SR 520 Bridge Replacement and HOV Program

To: Lynn Peterson, Washington Transportation Secretary
From: Julie Meredith, SR 520 Program Director
CC: Cam Gilmour, WSDOT Chief Operating Officer
Keith Metcalf, WSDOT Chief Engineer
Jeff Carpenter, WSDOT State Construction Engineer
Date: July 30, 2013
Re: SR 520 Program and Change Order Update

SUBJECT: Contract 008066
SR 520, Floating Bridge and Landings Project
Federal Aid No. BR-0520(047)
Change Order No. 108 – PFS Cycle 1 Repair

Description:
This is a WSDOT-Initiated Change in accordance with General Provisions Section 1-04.4(1). This change order addresses the addition of Work to repair cycle 1 Pontoons Furnished by the State (PFS), Pontoons T, U, V and W, to achieve the required Design Life of 75 years.

Figure 2-1. Crack mapping at the end wall, keel/top slabs, and potential problem areas

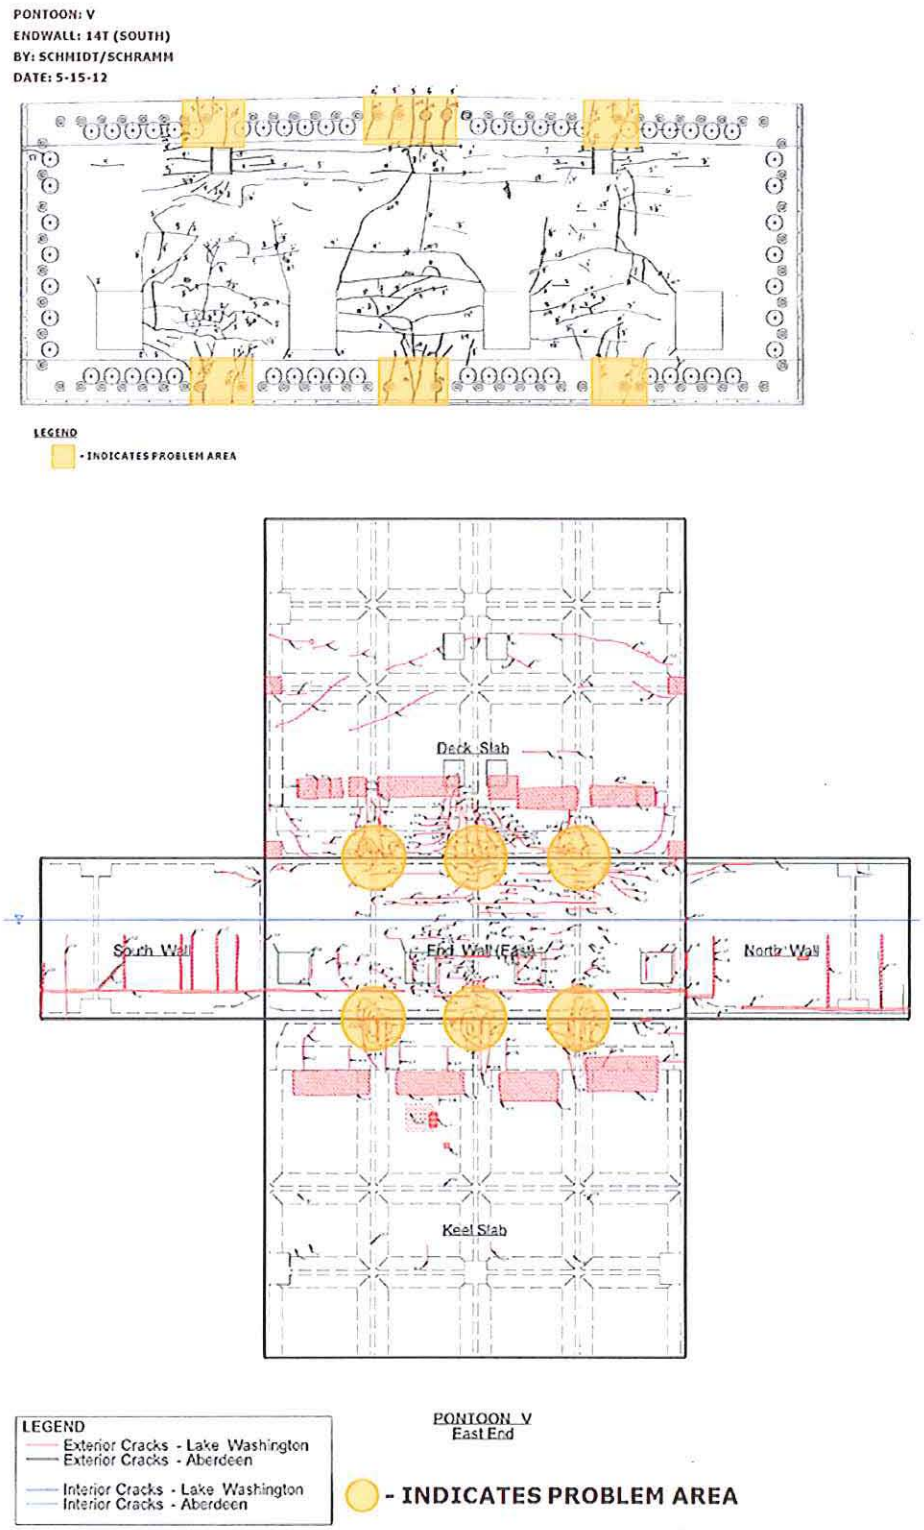
The crack/spall mapping on the keel slabs and bolt beams of Pontoons V and W are illustrated in Figure 2-1. The cracks and large spalls on the keel slabs are of the most structural significance, since they have not been repaired and manifest the following distinct features:

1. The cracks typically run up to 4' to 5' in the vertical direction on the end wall from the pontoon keel and extend up to 10' into the keel slab. The vertical cracks on the wall are connected to the longitudinal cracks in the keel slab. Figure 2-1 shows the crack mapping on the end wall (14T) and top/keel slabs of Pontoon V, and the potential problem areas.

2. Many of the cracks run vertically passing the bolt sleeves embedded in the bolt beams (Figure 2-1). When the bolt beams were subjected to tension from the post-tensioning of Pontoon V, it seems that the tension cracks tended to develop on the weak planes through which the bolt sleeves passed.

Our analysis concludes that the pontoons should be structurally repaired and strengthened prior to the pontoon assembly and put into service.

Figure 2-2 Crack mapping of the end wall T14 of Pontoon V

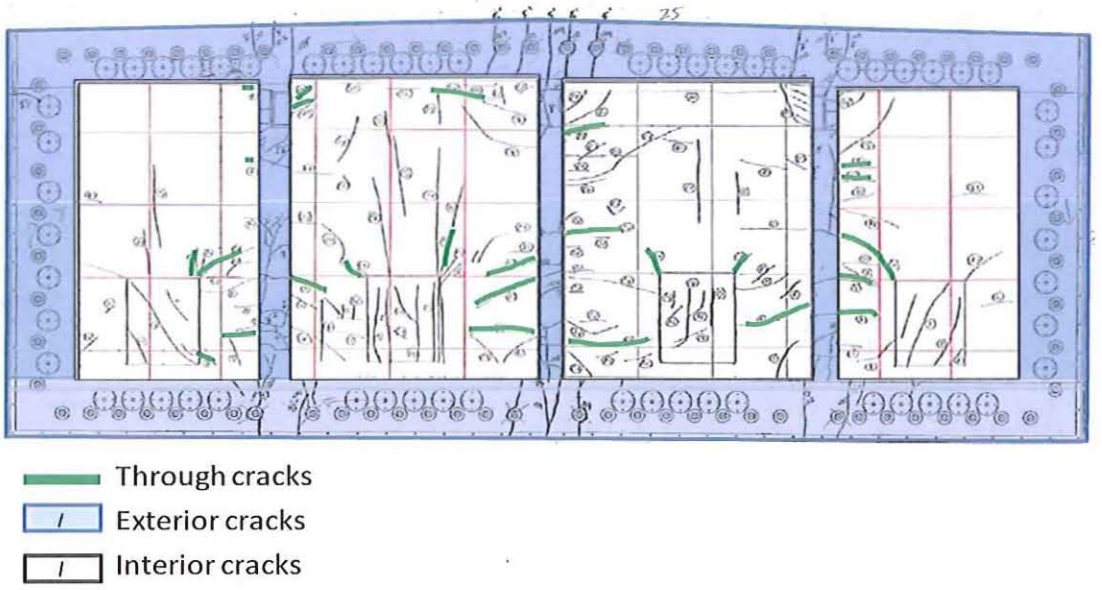
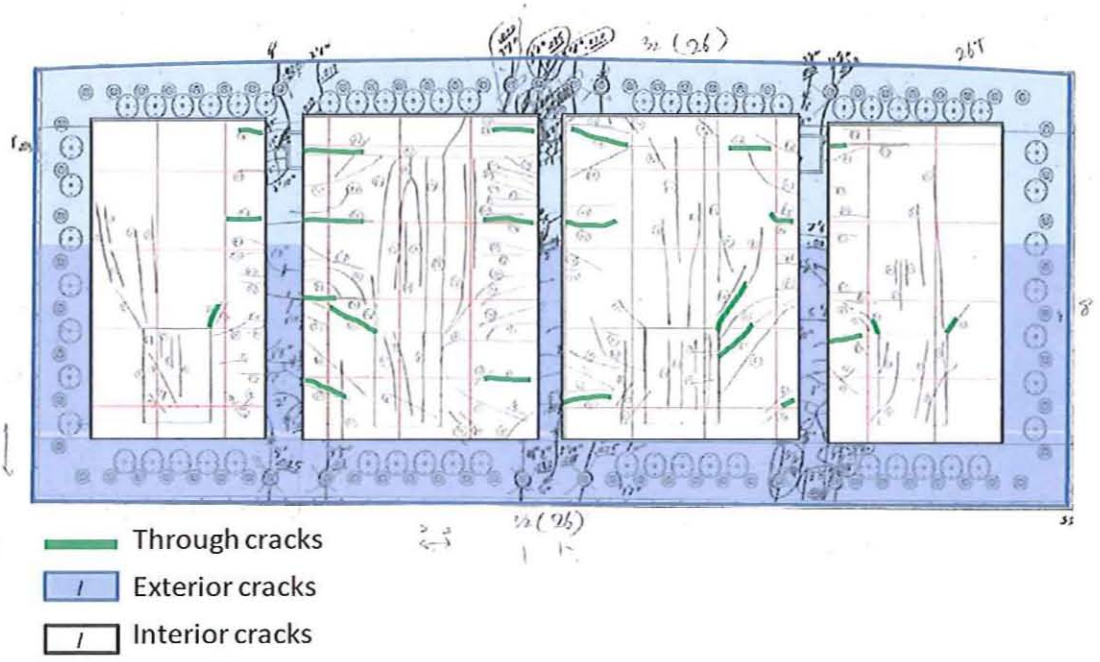
Finite element analysis indicates that the end walls were subjected to significant membrane tension and bending due to the post-tensioning. The analysis results are consistent with the field observations of the end walls. Figure 2-2 and Figure 2-3 superimposes a crack mapping of the interior surface onto that of the exterior surface of the end walls T14 and T1 of Pontoon V, respectively. The figures also highlight the through-thickness cracks on the end walls. It is apparent that the through cracks are limited in number and length.

existing cracks re-open in the future, the crack should be repaired with epoxy injection and an externally bonded CFRP system be installed on the interior surface of the end wall.

Figure A-1 Pontoon V East End External and Internal Repair Plan

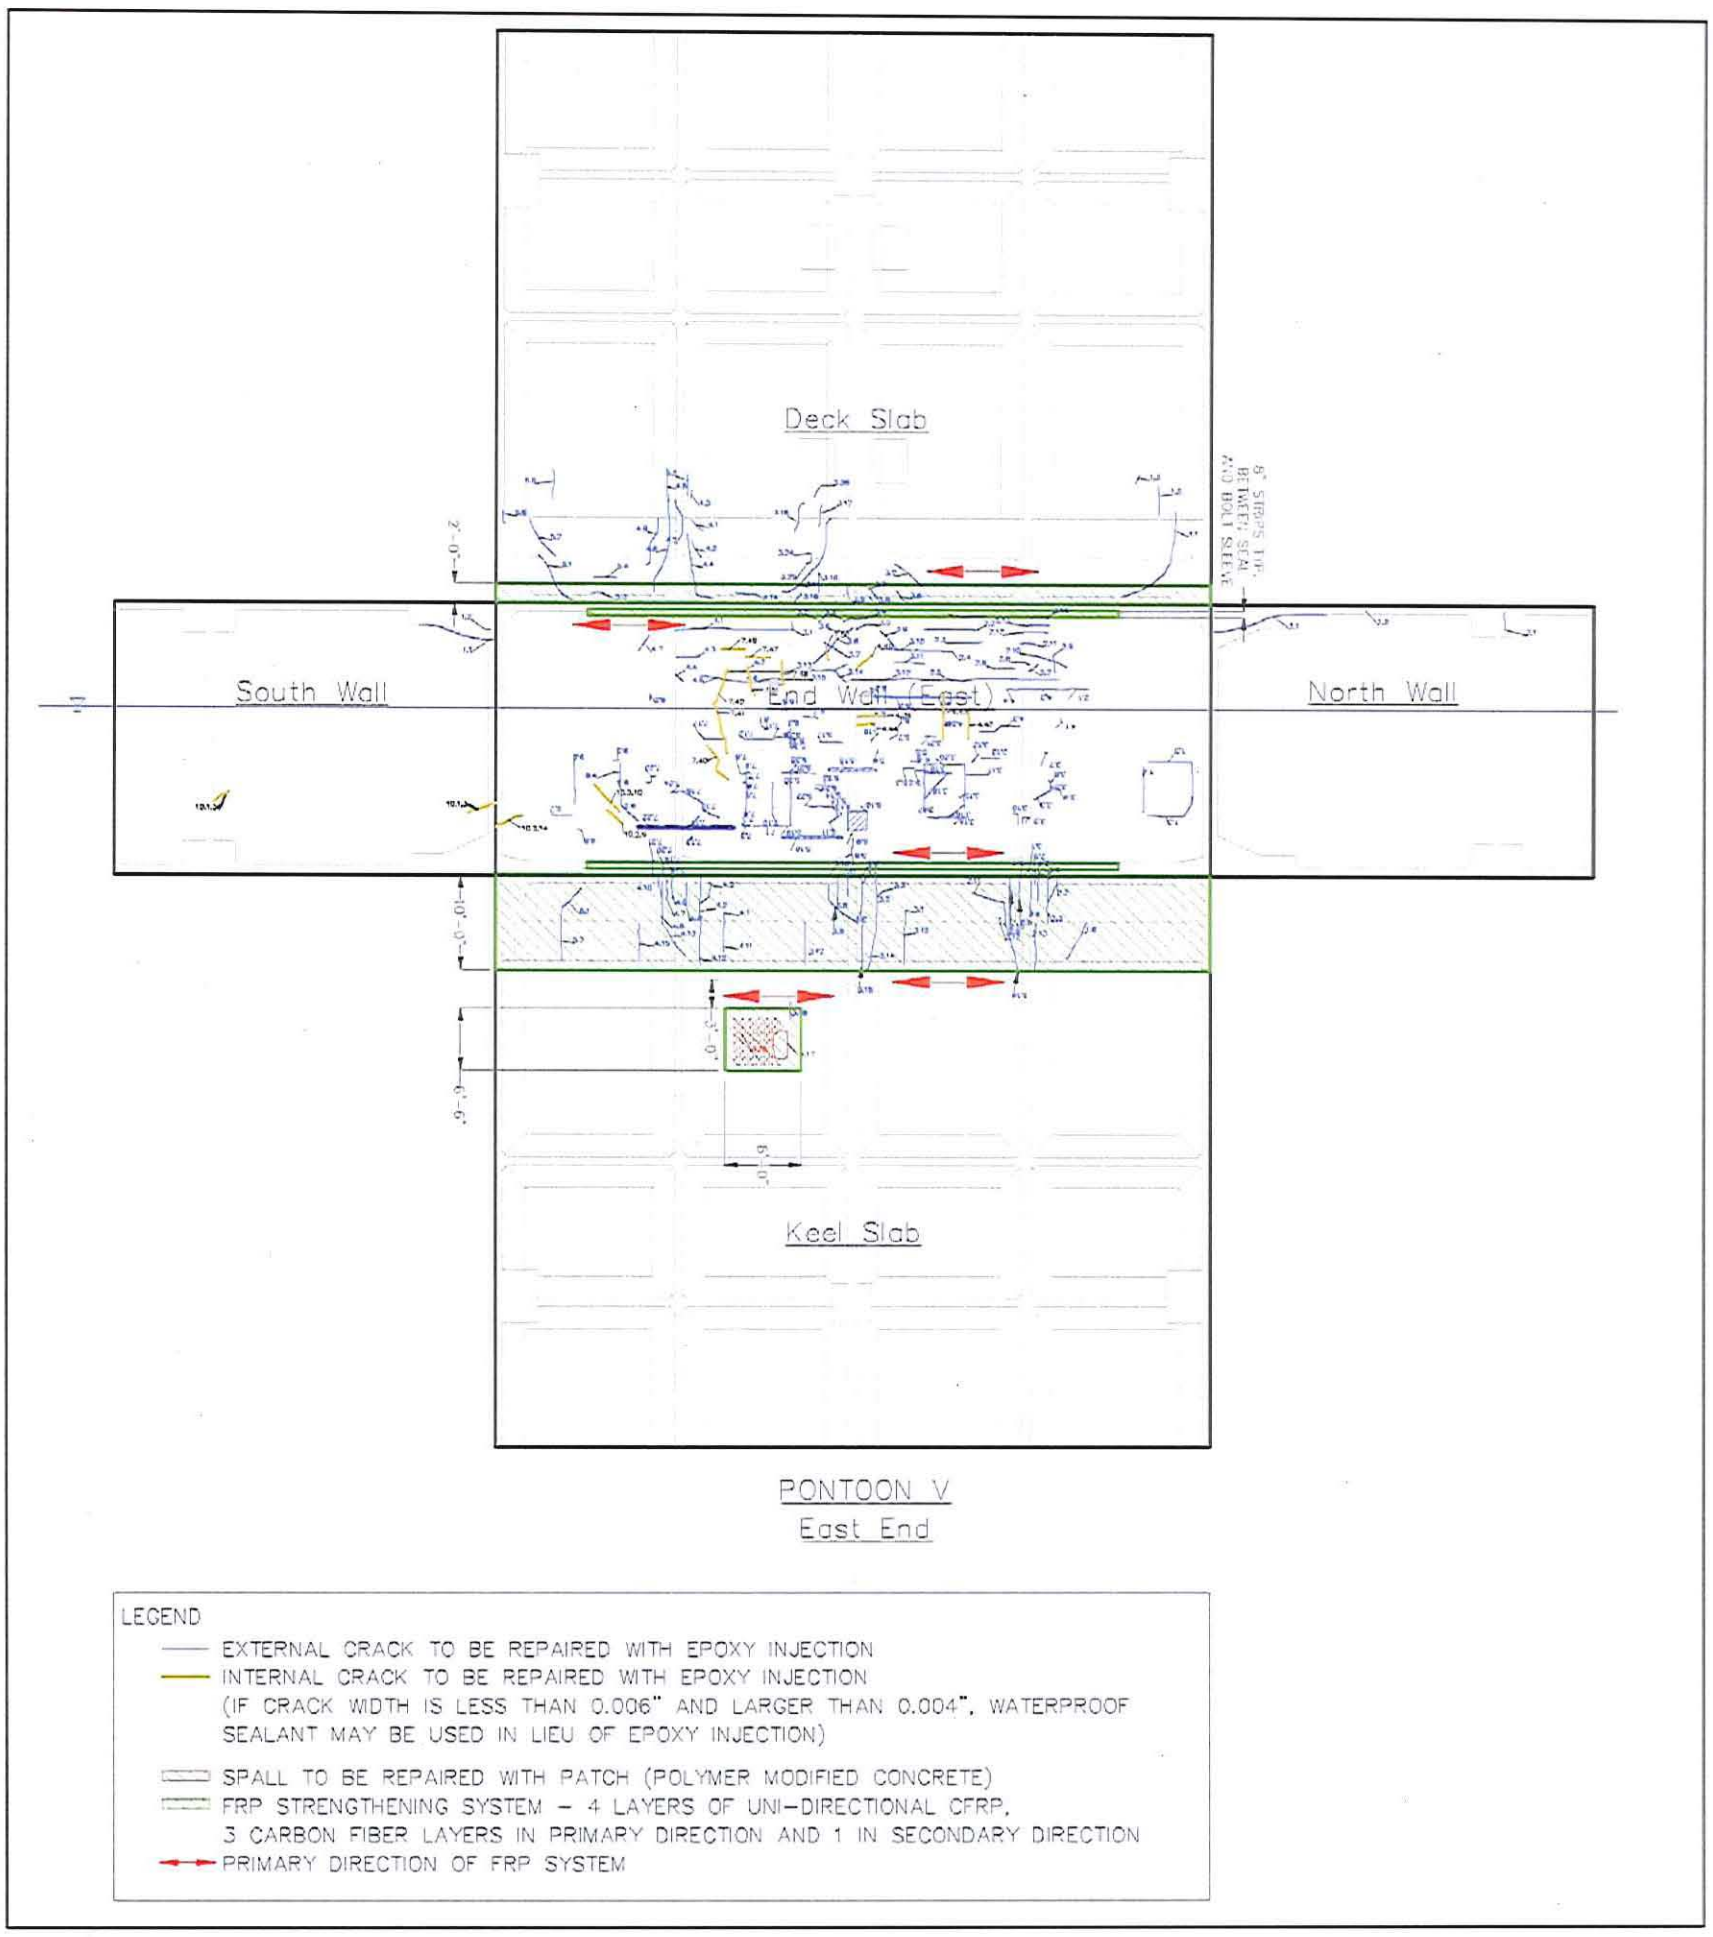
Cracks in the pontoon end walls which extended into the keel slab beneath the pontoons were discovered in the four Cycle 1 PFS provided to KGM in 2012. WSDOT determined that these cracks needed to be repaired and sealed to ensure the 75 year design life for the new structure. The repair plan developed and included in this change order meets the expectation for a 75 year design life.
